Access Compliance Report

Public Rights-of-Way

(Curb Ramps)

Intersection ID: 12573	Main Street: KENSINGTON_DR	Cross Street: NASSAU_BV	Location: NW
ADA ID: D51214D549EC	Ramp Type: PerpDiag	Initial Pass/Fail: Fail	Overall Compliance: No
Severity Score: 33.75			
Codes/Mitigation Info/Possible Solution		Field Measurements/Component Compliance

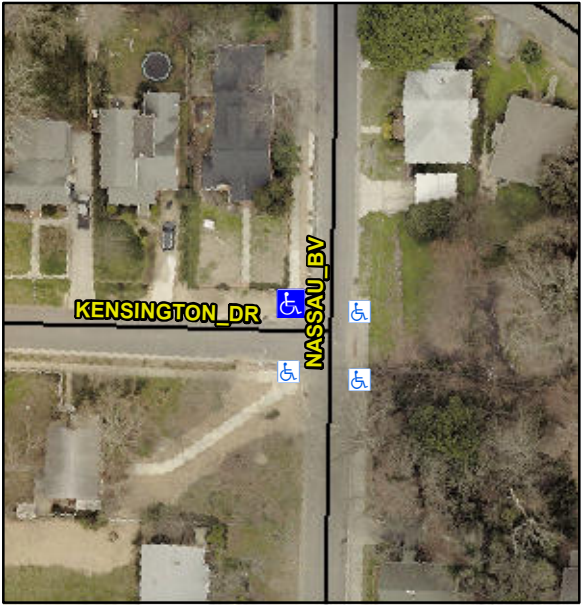
Possible Solutions:	Compliance	Description	Data	Compliance	Description	Data
	Remove & Replace Curb Ramp With Two New Directional Ramps or Equivalent.	N/A	Ramp Length (in)	35.0	No	Ramp Slope (%)	13.0
		No	Ramp Width (in)	47.0	Yes	Ramp XSlope (%)	0.5
		N/A	Flare Type LT	N/A	N/A	Flare Type RT	N/A
		N/A	Flare Slope LT (%)	N/A	N/A	Flare Slope RT (%)	N/A
		N/A	Flare Traversable LT?	N/A	N/A	Flare Traversable RT?	N/A
		N/A	Landing Length (in)	N/A	N/A	DWS Provided?	N/A
		N/A	Landing Width (in)	N/A	N/A	DWS Contrast?	N/A
		N/A	Landing Slope (%)	N/A	N/A	DWS Length (in)	N/A
		N/A	Landing X Slope (%)	N/A	N/A	DWS Full Width?	N/A
		N/A	Landing Curb? (Y/N)	N/A	N/A	DWS Offset (in)	N/A
		N/A	Shared Landing?	N/A			
		N/A	Gutter Ponding?	N/A	N/A	Gutter Slope (%)	N/A
		N/A	Gutter Lip Ht (in)	N/A	N/A	Gutter X Slope (%)	N/A
		N/A	Painted X Walk1?	No	N/A	Painted X Walk2?	No
			X Walk 1 Direction	To S		X Walk 2 Direction	To E
		N/A	X Walk 1 Width (in)	N/A	N/A	X Walk 2 Width (in)	N/A

X Walk 1 Slope (%)	0.3		X Walk 2 Slope (%)	1.2
			X Walk 1 X Slope (%)	0.9		X Walk 2 X Slope (%)	1.2
		N/A	Ramp inside XWalk1?	N/A	N/A	Ramp inside XWalk2?	N/A
<p>Surveyor Notes:</p> <p>N/A</p> <p>PROW/ADA:</p> <p>Not Found, R304.5.1, R304.2.2</p>			Road Slope (%)	0.0	N/A	Clear Space?	N/A
			Road X Slope (%)	2.3	N/A	Clear Space to XWalk (in)	N/A
<p>Total Cost:</p> <p>\$ 3200.00</p>		N/A	Any Obstructions?	N/A	N/A	Storm Grate/Utility Hazard?	N/A
			Obstruction Type			Storm Grate/Utility Type	
					N/A		N/A
					Yes	Surface Condition? (G/P)	Good
